**Report: Cody Mauro**  
**Function: Test, Adjust, & Balance**  
**Date: 10/03/2025**  
**Completed By: National TAB**

**PROJECT**  
**09-29-25 CAVA SAVANNAH, GA**  
**(OGLETHORPE MALL)**

**Project Issue Information**

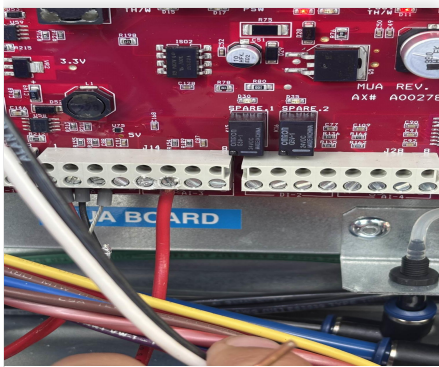
**Issue Name :** MAU FAN CONTROL  
**Description :** Fan speed not programmed into hood HMI. Control system not wired into MAU board on the roof. Manually changed speed on VFD from 48Hz to 52Hz.  
**Created By :** National TAB                      **Assigned To :** National TAB - Cody Mauro  
**Status :** Open  
**Priority :** Urgent                                      **Asset Tag :**  
**Originated Date :** 10/01/2025 - Cody Mauro - National TAB

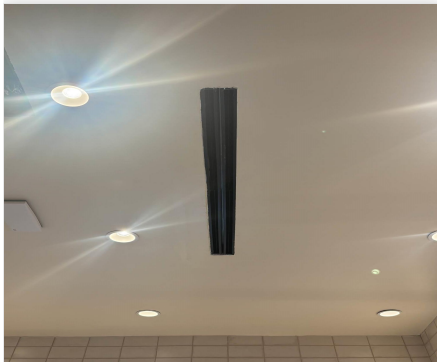
**Issue Name :** RTU2 REMOTE DAMPERS  
**Description :** Dampers for diffusers 2-1 through 2-8 are inaccessible. They all sit above dry wall ceiling. SGRD2-8 not pictured, but duct line runs close to hood, which sits above drywall ceiling.  
**Created By :** National TAB                      **Assigned To :** National TAB - Cody Mauro  
**Status :** Open  
**Priority :** High                                      **Asset Tag :**  
**Originated Date :** 09/30/2025 - Cody Mauro - National TAB
